CONE ARCHITECTURE AVALON APARTMENTS

AVALON APARTMENTS #3029952 - LU REC CONE ARCHITECTURE

### **RESPONSE EARLY DESIGN GUIDANCE**

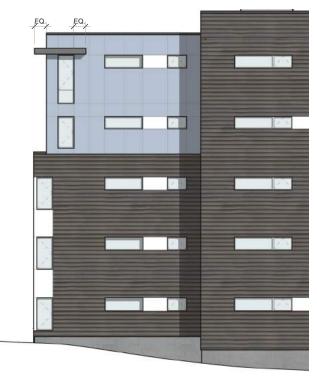
2. Height Bulk and Scale Staff appreciates the simplicity of this project's massing and recognizes that the height of the project is code-compliant, but has concerns regarding the alley (west) edge. Directly across this alley the zoning changes from Midrise to single-family. Guideline CS2-D-3 speaks directly to this condition.

CS2-D-3. Zone Transitions: For projects located at the edge of different zones, provide an appropriate transition or complement to the adjacent zone(s). Projects should create a step in perceived height, bulk and scale between the anticipated development potential of the adjacent zone and the proposed development.

a. Staff asks that an appropriate scale-mitigating strategy be developed for this edge. The most obvious would be to have the upper two floors step back significantly on the alley edge, but other solutions are possible. (CS2-D-3)

We have stepped the building back at the upper two floors on the west alley-facing façade, as requested. At the alley, and adjacent to the single-family zoning transition, this massing move creates a 3-story datum which also relates to the 3-story townhouse project to the north. A material change here reinforces this change in scale.

3A, 3B

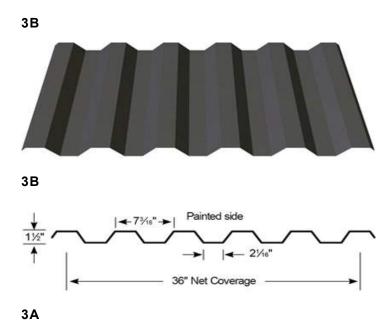
- 3. Design Concept. Staff generally supports the proposed concept; a simple composition of program-driven massing choices, clad in high quality materials and highly-glazed on the street-facing elevation. (DC2-B, CS2-C-1, CS2-A-2)
- a. As to the setback departures, the language in SMC 23.45.518 (setbacks in MR zones) is clearly intended to create a 'step' in massing at 42 feet. This proposal would circumvent that 'ask' in favor of a (vertically) unmodulated plane from ground to top.

b. Staff is possibly open to this approach, but its success (and their support) would be dependent on a sophisticated composition of high-quality materials, akin to the precedents provided on p. 16-17. (DC4-A, DC2-B)

Rather than arbitrarily step the building or change materials at 42 feet, this project aims to maintain the simple composition of volumes that relate to the interior functions and program of the building. Moreover, the project proposes to reinforce this composition of planes and masses with material changes.

The simple composition of program-driven massing choices will be delineated with high-quality materials, specifically a ribbed metal panel with integral color will be the predominate exterior material. Painted cement board panel siding will express the stair volumes and also serve as white infill panels to organize the window openings. The projecting bay at the east façade and the upper 2 floors at the west façade are proposed as fiber cement panels painted blue to add a contrasting color to the project palette.

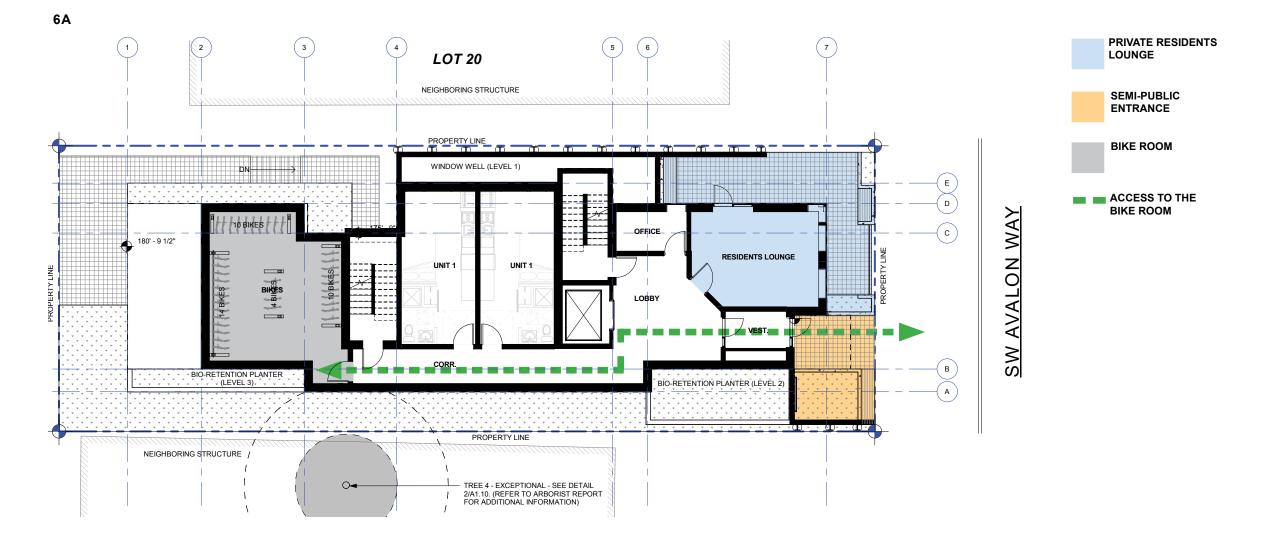
6. Entry Area. Staff supports the location of the principal entry and the heavily glazed and graciously-scaled lobby. Please provide complete details for this area that describe the experience of arrival for residents and guests, whether on foot or cycle. (PL3-A-1, PL3-A-2, PL3-A-4)

The main building entrance has been further refined to create a semi-public entrance patio for the building. A broad, built-in bench and planters frame the entrance at the ground and engage the sidewalk. Overhead, a steel awning with cedar on the underside highlight the building's front door.

North of the entrance patio is a private outdoor amenity area that is connected to the ground level residents' lounge with large windows and a separate exterior door. More planters and built-in benches define an outdoor space for tenants slightly above and separated from the sidewalk.
